Exhibit A
(Ord. 2023-09-05)

City of Quinlan Local Code Amendments:

Exhibit A, Section A-1
2018 IBC Local Amendments
(Option A Selected)
Adopted 9-11-23

Recommended Amendments to the 2018 International Building Code

****Figure R602.6.1; delete the figure and insert the following figure:**

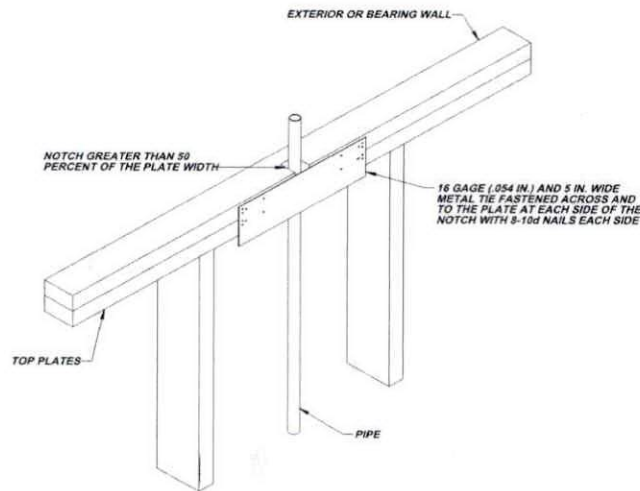
(Amendment to 2015 IRC carried forward to 2018 IRC also provides additional assurance of maintaining the integrity of the framing by spreading the nailing pattern.)

ADD: Figure: 25 TAC §265.186 (e) (6)

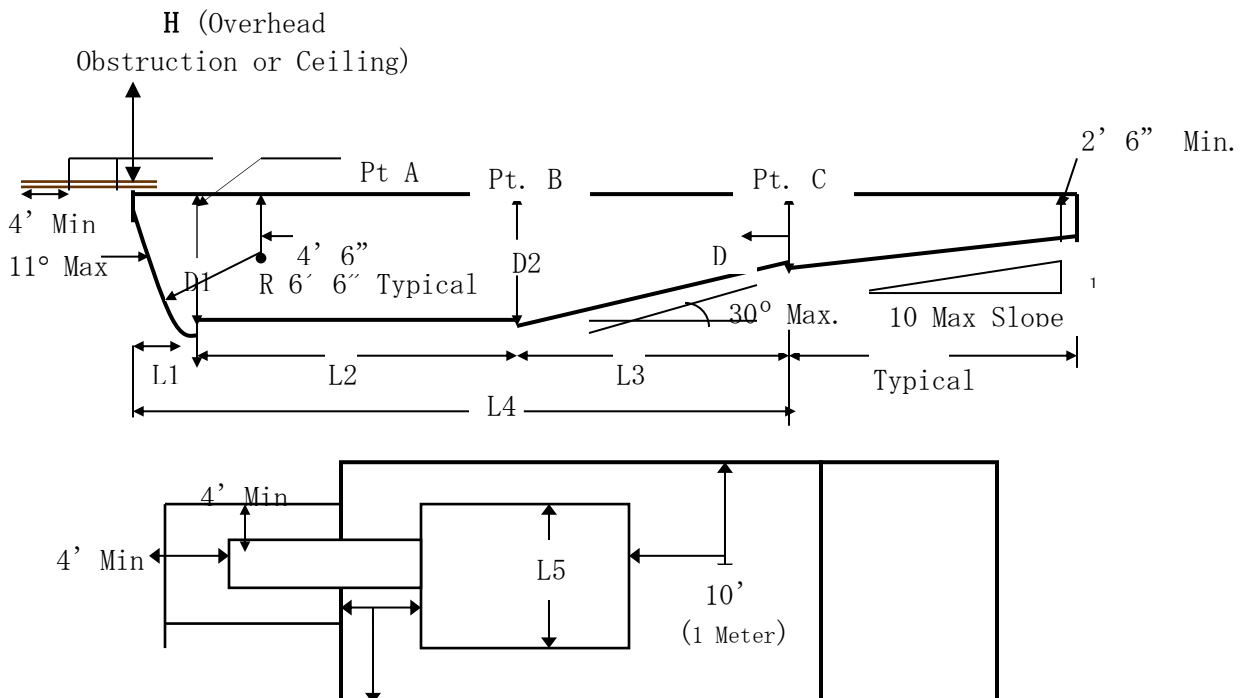
402.12 Water envelopes. The minimum diving water envelopes shall be in accordance with ~~Table 402.12~~ **Texas department of State Health services, Administrative Code Title 25, Chapter 265, Section 186 (e) and Figure: 25 TAC 256.186 (e) (6).** (Delete Table 402.12 and Figure 402.12)

Maximum Diving Board Height Over Water	¾ Meter	1 Meter	3 Meters
Max. Diving Board Length	12 ft.	16 ft.	16 ft.
Minimum Diving Board Overhang	2 ft. 6 in.	5 ft.	5 ft.
D1 Minimum	8 ft. 6 in.	11 ft. 2 in.	12 ft. 2 in.
D2 Minimum	9 ft.	10 ft. 10 in.	11 ft. 10 in.
D3 Minimum	4 ft.	6 ft.	6 ft.
L1 Minimum	4 ft.	5 ft.	5 ft.
L2 Minimum	12 ft.	16 ft. 5 in.	19 ft. 9 in.
L3 Minimum	14 ft. 10 in.	13 ft. 2 in.	13 ft. 11 in.
L4 Minimum	30 ft. 10 in.	34 ft. 7 in.	38 ft. 8 in.
L5 Minimum	8 ft.	10 ft.	13 ft.
H Minimum	16 ft.	16 ft.	16 ft.
From Plumbet to Pool Wall at Side	9 ft.	10 ft.	11 ft. 6 in.
From Plumbet to Adjacent Plumbet	10 ft.	10 ft.	10 ft.
